SONY

Ref. No.			
Subject			
Earpad Repair procedure change			
Model□(System model)	Destination	Serial number	Color
MDR-1R	CE7	ALL	Black
MDR-1R	CN	ALL -	Black
MDR-1RMK2	CN	ALL -	Black
MDR-1R	E	ALL -	Black
MDR-1RMK2	E	ALL -	Black
MDR-1R	UC	ALL -	Black

EAR PAD ASSY

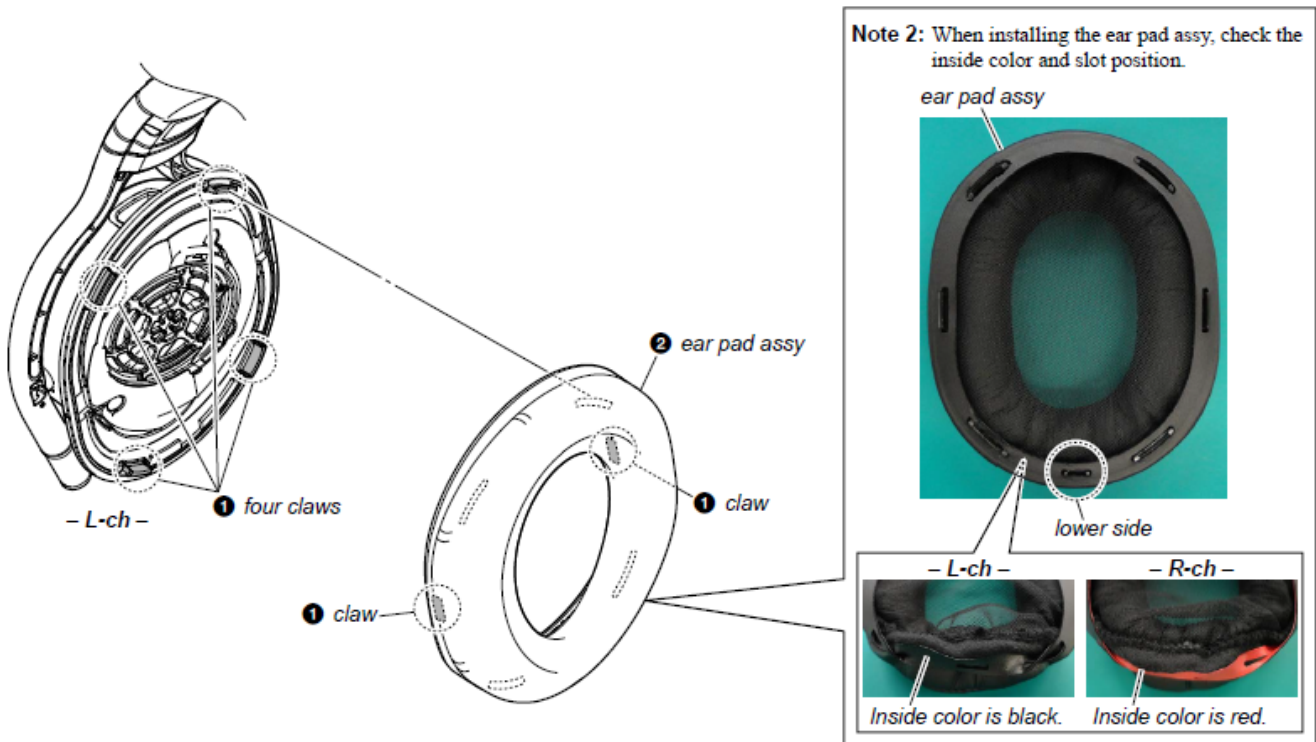
Ear Pad plate is no longer available, needs to be re-used on replacement Ear Pads.

Remove the plate from customer's EAR PAD.

1. Remove the ear pad from the main unit.

Note: Please work carefully so as not to damage the plate when removing it

2. Disassemble the ear pad into a cushion and a plate.

Note : Please be careful not to scratch as the plate will be diverted.

3. Attach the removed plate to the new cushion.

Note: Check the engraving of the plate part [L/R] and attach a new cushion part to combine.
